Addendum to Statement of Environmental Effects for the subdivision of Lots 1 and 2 DP792596, 8140 Pacific Highway, South Urunga into 233 residential lots

Development Application 2014/DA-00129 South Urunga Subdivision

Response to OEH Comments 6 and 7 in Development Application 2014/DA-00129- 223 Lot Subdivision, Pacific Highway, South Urunga (OEH Comments Reference DOC14/189586)

Revised Development Footprint

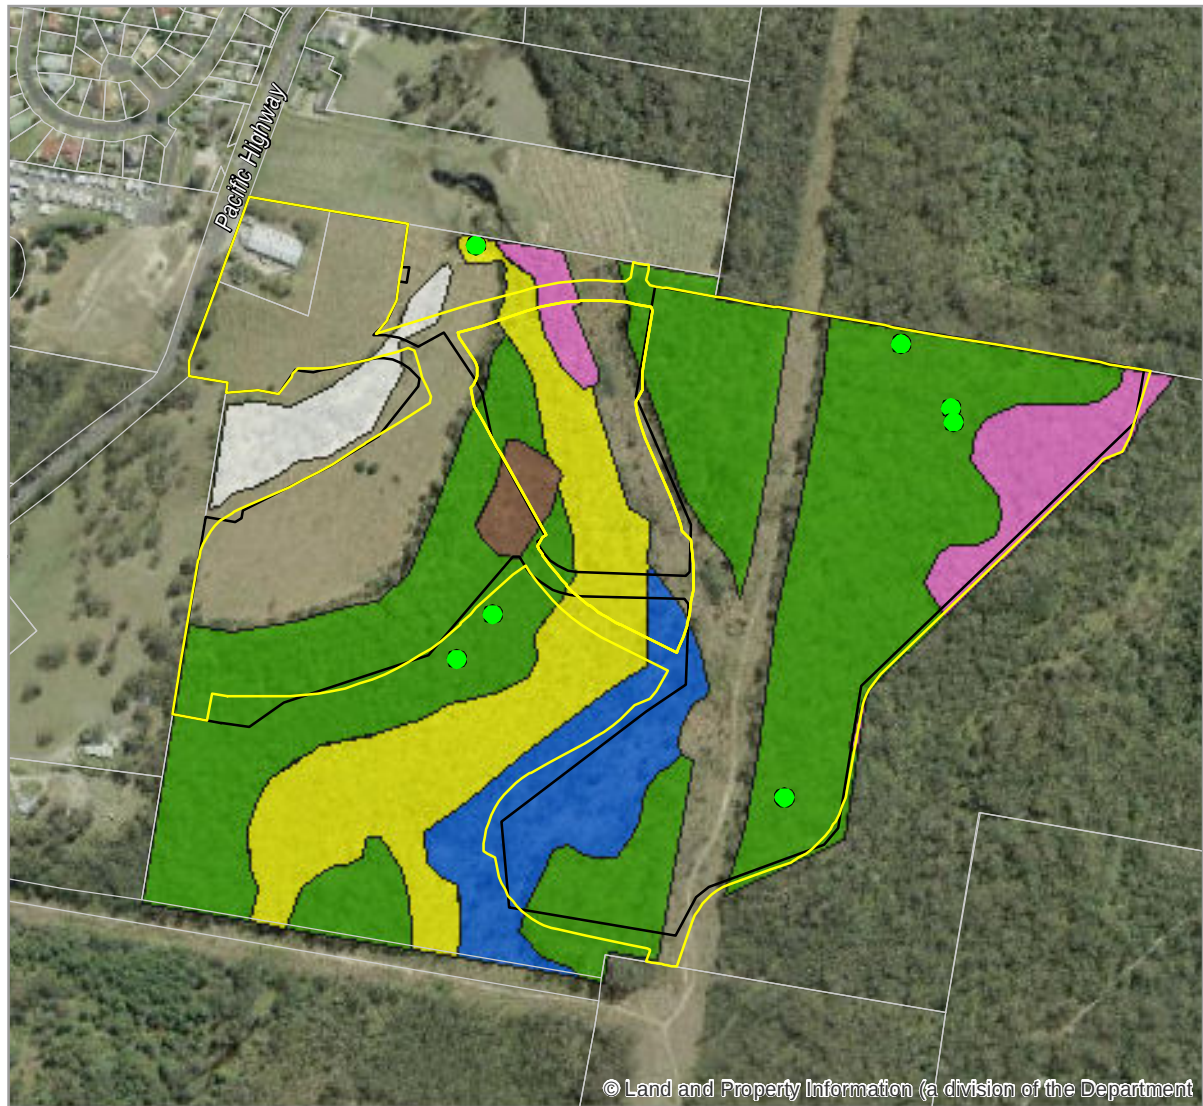
Native vegetation removal requirements of the revised development are shown in the table below and illustrated in **Appendix D**. The revised development footprint would result in the removal of 20.46 ha of native vegetation, an increase of 1.34 ha. This includes removal of an additional 0.14 ha of the *Threatened Species Conservation Act 1995* (TSC Act) listed Endangered Ecological Community (EEC) Swamp Sclerophyll on Coastal Floodplain. Approximately 0.08 ha of Subtropical Coastal Floodplains Forest of the NSW North Coast Bioregion would also require removal.

Conceptual Water Supply Reservoir Plan

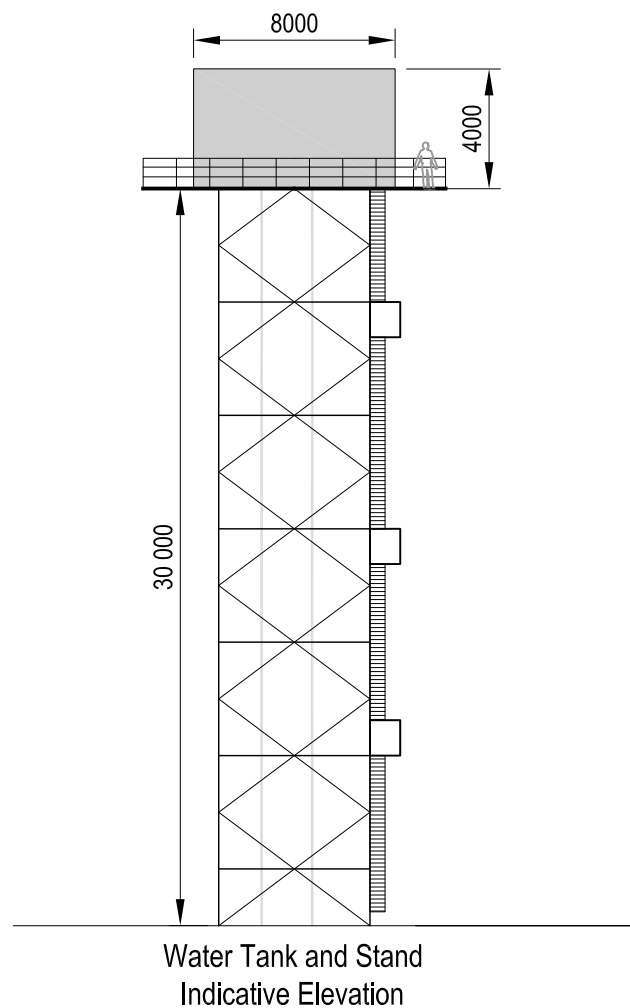
Councils Manager, Water and Waste Water was contacted to determine design requirements for the required water supply reservoir. A conceptual plan (refer **Appendix E**) has been prepared based on advice received.
